Blue Print

ADN12352, ADR162314

Nissan Qashqai 2013 > (J11) model, X-Trail 2014 > (T32)

Fuel filter

Fig. 1 ADN12352

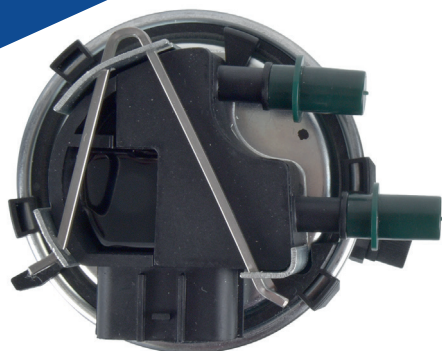
The water in the fuel, lamp is illuminated on the vehicles dashboard display after the fuel filter has been replaced.

The incorrect filter has been fitted to the vehicle during servicing. This is due to a change in specification with the fuel heater/water sensor installed in the filter. This effects Qashqai models built from August 2014 and X-Trail models from December 2014.

The correct fuel filter required for the Qashqai models built before August 2014 and X-Trail models before December 2014 can be identified by a black fuel heater/water sensor inbuilt into the filter (Fig. 1).
